Access Compliance Report

Public Rights-of-Way

Intersection ID: 24360	Main Street: BIRNEN_DR	Cross Street: ESSEN_LN	Location: NE
ADA ID: 3F6BD2660292	Ramp Type: PerpDiag	Initial Pass/Fail: Fail	Overall Compliance: No
		Severity Score: 25

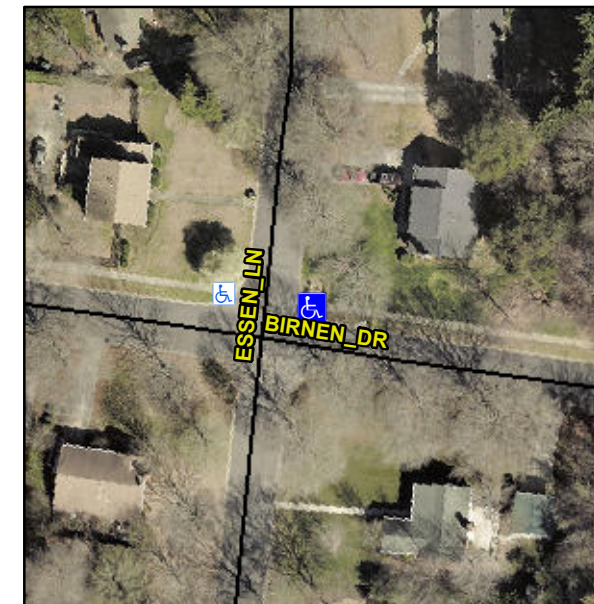
Not Found, R304.2.2, R304.5.3

Compliance	Description	Data	Compliance	Description	Data
N/A	Ramp Length (in)	54.0	No	Ramp Slope (%)	9.7
Yes	Ramp Width (in)	48.0	No	Ramp XSlope (%)	5.7
N/A	Flare Type LT	N/A	N/A	Flare Type RT	N/A
N/A	Flare Slope LT (%)	N/A	N/A	Flare Slope RT (%)	N/A
N/A	Flare Traversable LT?	N/A	N/A	Flare Traversable RT?	N/A
N/A	Landing Length (in)	N/A	N/A	DWS Provided?	N/A
N/A	Landing Width (in)	N/A	N/A	DWS Contrast?	N/A
N/A	Landing Slope (%)	N/A	N/A	DWS Length (in)	N/A
N/A	Landing X Slope (%)	N/A	N/A	DWS Full Width?	N/A
N/A	Landing Curb? (Y/N)	N/A	N/A	DWS Offset (in)	N/A
N/A	Shared Landing?	N/A			
N/A	Gutter Ponding?	N/A	N/A	Gutter Slope (%)	N/A
N/A	Gutter Lip Ht (in)	N/A	N/A	Gutter X Slope (%)	N/A
N/A	Painted X Walk1?	No	N/A	Painted X Walk2?	No
	X Walk 1 Direction	To NW		X Walk 2 Direction	To SW
N/A	X Walk 1 Width (in)	N/A	N/A	X Walk 2 Width (in)	N/A
	X Walk 1 Slope (%)	3.5		X Walk 2 Slope (%)	5.3
	X Walk 1 X Slope (%)	3.5		X Walk 2 X Slope (%)	1.1

Remove & Replace Curb Ramp With Two New Directional Ramps or Equivalent.
